2000-1 Addison Circle  
1998-1999 Hutt-Zollars Correspondence

Re: Addison Circle

PROJECT: ADDISON CIRCLE PHASE II - PUBLIC INFRASTRUCTURE  
 JOB NUMBER: 9809 / CHANGE ORDER NO. 1 (UTILITIES)  
 OWNER: TOWN OF ADDISON  
 CONTRACTOR: NORTH TEXAS CONTRACTING, INC.  
 DATE: 09/09/98

Spectrum Drive Esplanade  
Proposed Revisions

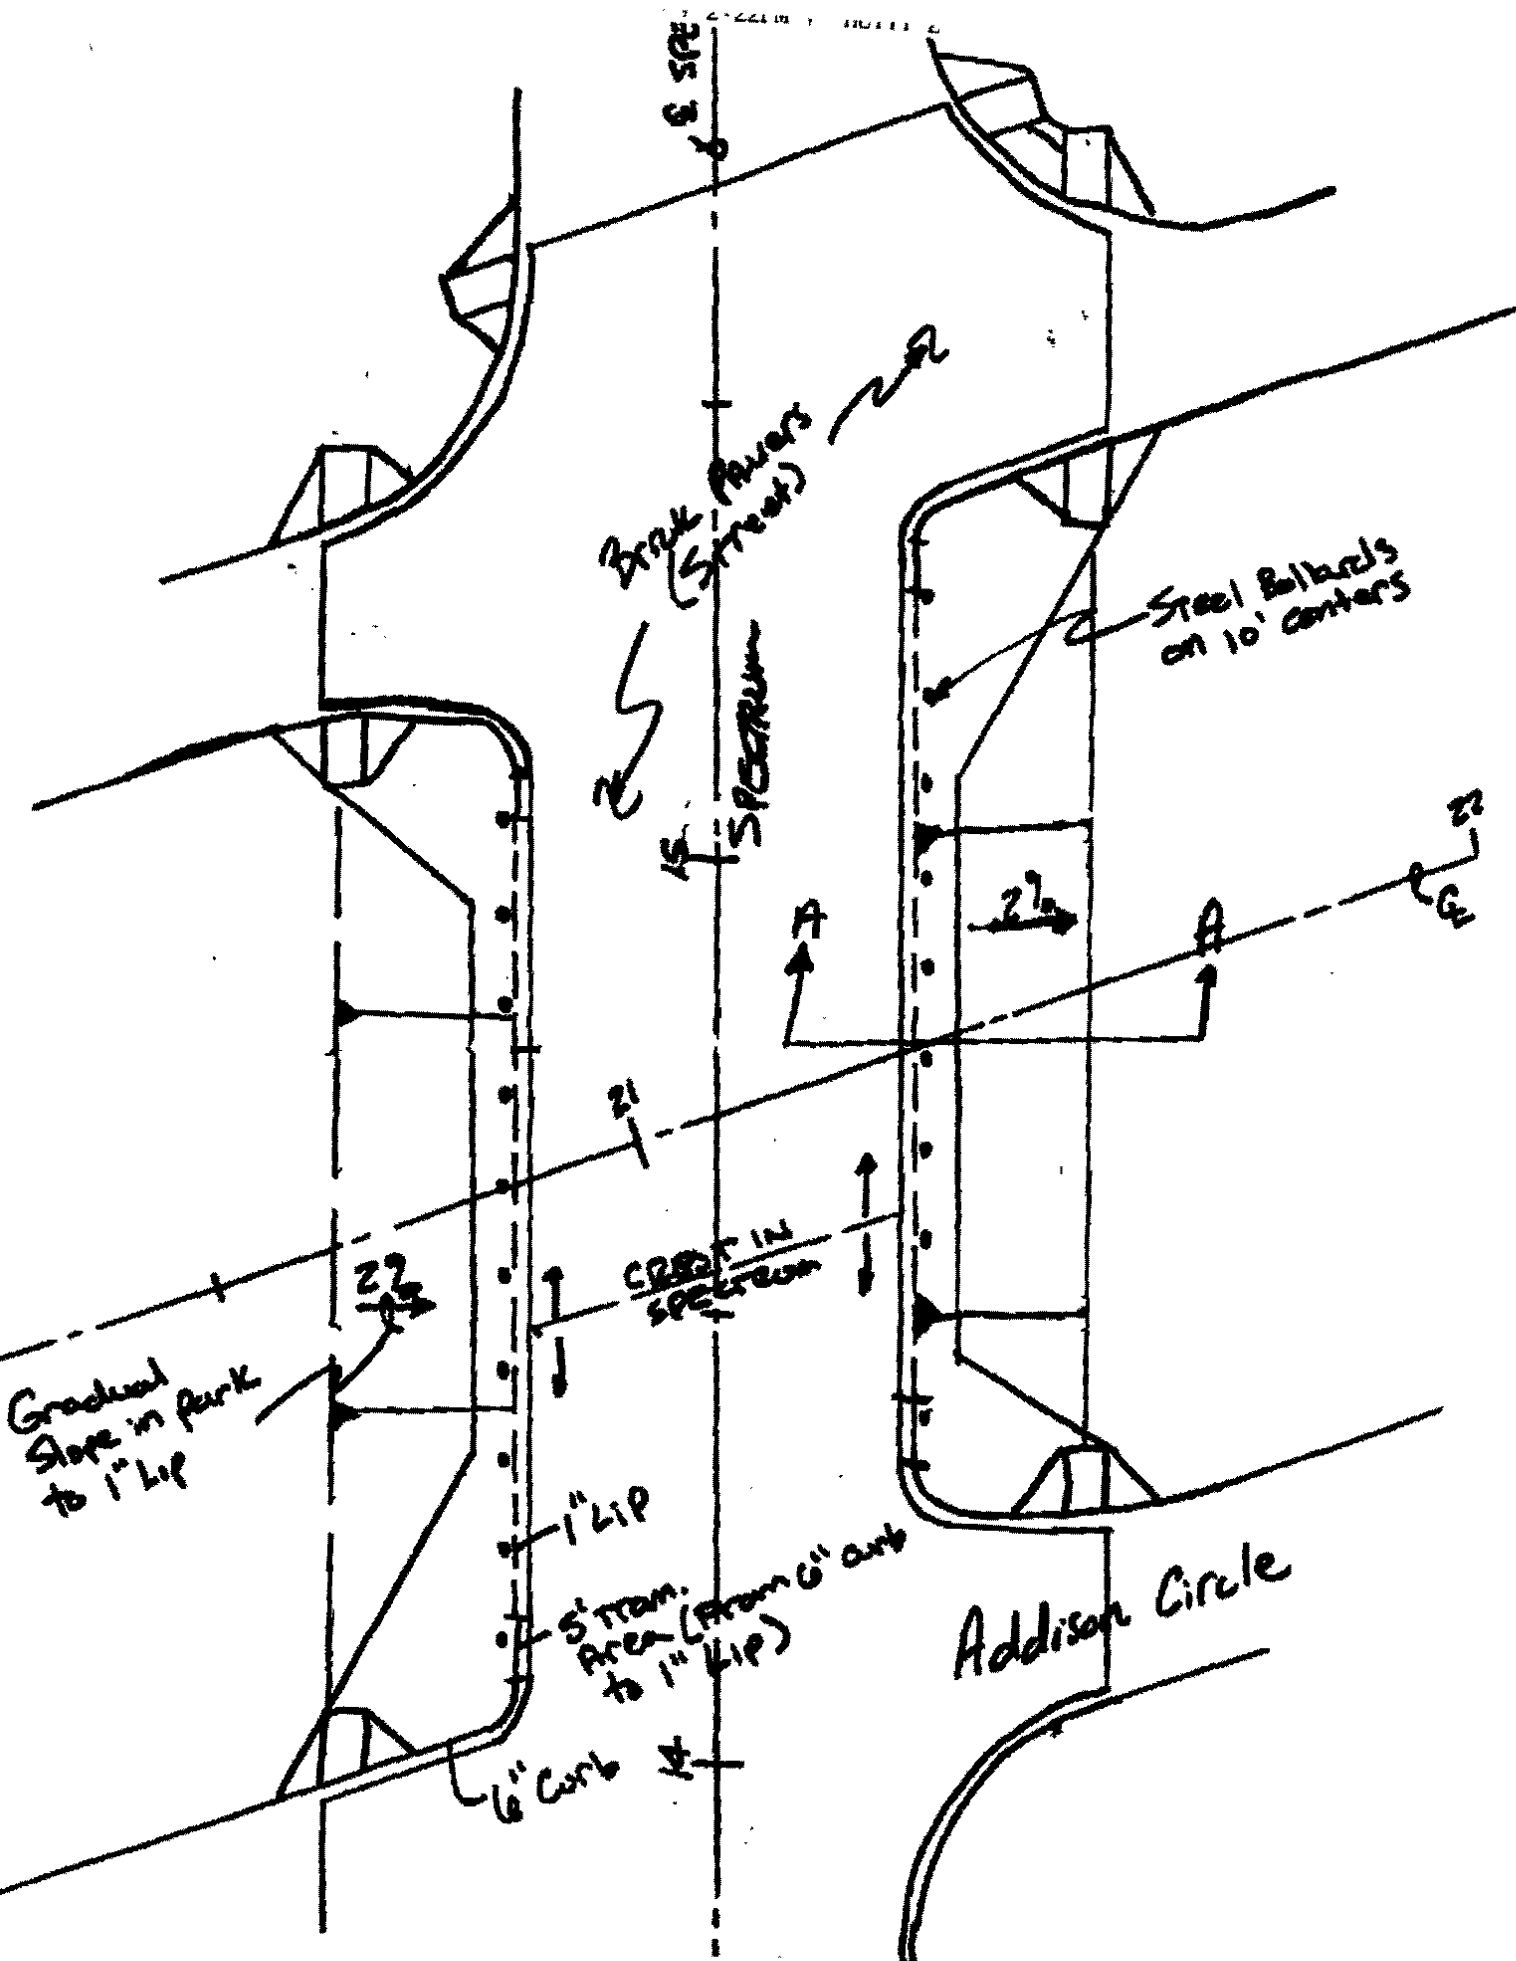
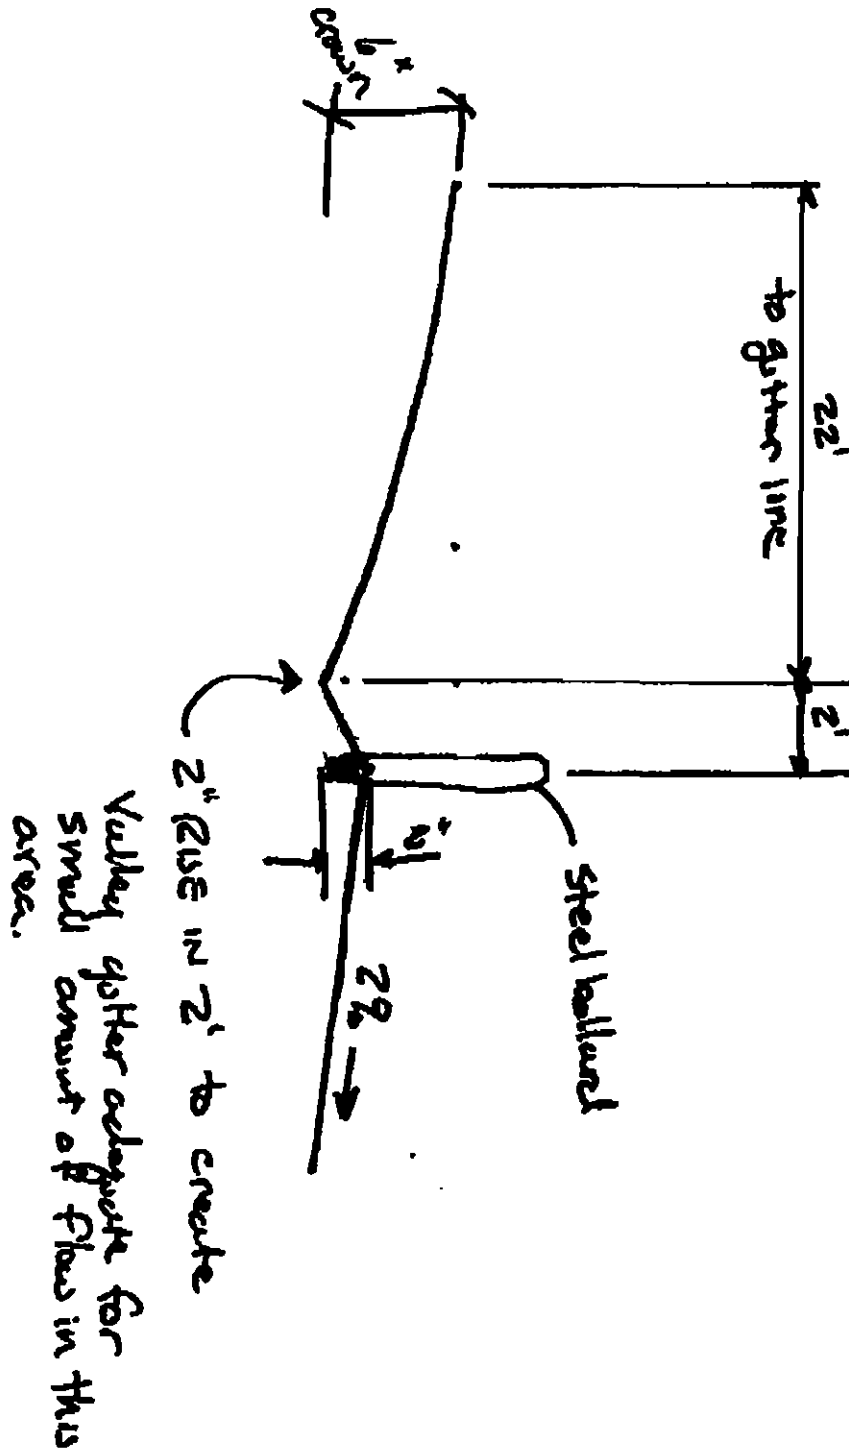
Enclosed please find a schematic drawing illustrating the proposed revision to the current design for the Spectrum Drive esplanade area. It has been the intent throughout the planning stages to have this section of pavement at the same, or at least appear to be at the same, level as the park to create a plaza effect. The city had many concerns about raising the pavement to the level of the park and a resolution was not reached prior to the job going out for bid. As a result the current design calls for a standard curb and gutter section.

We propose to revise the current design as follows:

- Transition from a 6" curb to a small valley gutter section which will slope 2" vertically in 2 horizontal feet from the gutter line on Spectrum Drive. This valley gutter section will occur between the curb returns at the Spectrum Drive and Addison Circle intersections.
- Slope the park at 2% to the valley gutter on the west side of Spectrum and at 2% away from the valley gutter on the east side of Spectrum.
- Add steel bollards on 10' centers 2' back from the gutter line of Spectrum Drive.

We hope this is an adequate compromise that will create the plaza effect that the designers and planners set out to achieve as well as addressing the safety concerns of public works. As you know this area is scheduled for paving soon, therefore we would appreciate your efforts in expediting the review of the proposed revisions.
